Access Compliance Report

Public Rights-of-Way

Intersection ID: 45518	Main Street: COTTON_PRESS_RD	Cross Street: MEADOW_BOTTOM_RD	Location: E
ADA ID: 238068B6248F	Ramp Type: Combination1Diag	Initial Pass/Fail: Fail	Overall Compliance: No
		Severity Score: 0

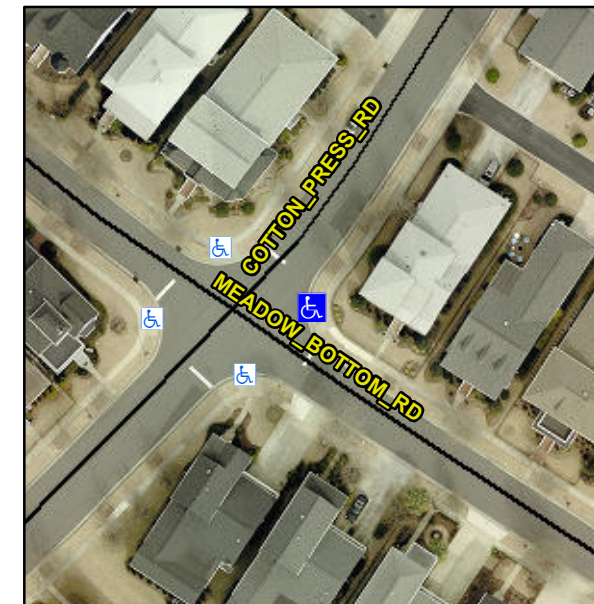
Not Found, R304.5.1, R304.2.2, R304.5.3

Compliance	Description	Data	Compliance	Description	Data
N/A	Ramp Length LT (in)	47.0	N/A	Ramp Length RT (in)	39.0
Yes	Ramp Width LT (in)	48.0	Yes	Ramp Width RT (in)	48.0
Yes	Ramp Slope LT (%)	7.7	Yes	Ramp Slope RT (%)	5.3
Yes	Ramp XSlope LT (%)	2.0	No	Ramp XSlope RT (%)	4.0
N/A	Ramp Length (in)	71.0	No	Ramp Slope (%)	10.7
No	Ramp Width (in)	36.0	No	Ramp XSlope (%)	5.9
N/A	Flare Type LT	N/A	N/A	Flare Type RT	N/A
N/A	Flare Slope LT (%)	N/A	N/A	Flare Slope RT (%)	N/A
N/A	Flare Traversable LT?	N/A	N/A	Flare Traversable RT?	N/A
N/A	Landing Length (in)	N/A	N/A	DWS Provided?	N/A
N/A	Landing Width (in)	N/A	N/A	DWS Contrast?	N/A
N/A	Landing Slope (%)	N/A	N/A	DWS Length (in)	N/A
N/A	Landing X Slope (%)	N/A	N/A	DWS Full Width?	N/A
N/A	Landing Curb? (Y/N)	N/A	N/A	DWS Offset (in)	N/A
N/A	Shared Landing?	N/A			
N/A	Gutter Ponding?	N/A	N/A	Gutter Slope (%)	N/A
N/A	Gutter Lip Ht (in)	N/A	N/A	Gutter X Slope (%)	N/A
N/A	Painted X Walk1?	No	N/A	Painted X Walk2?	No

Remove & Replace Curb Ramp With Two New Directional Ramps or Equivalent.
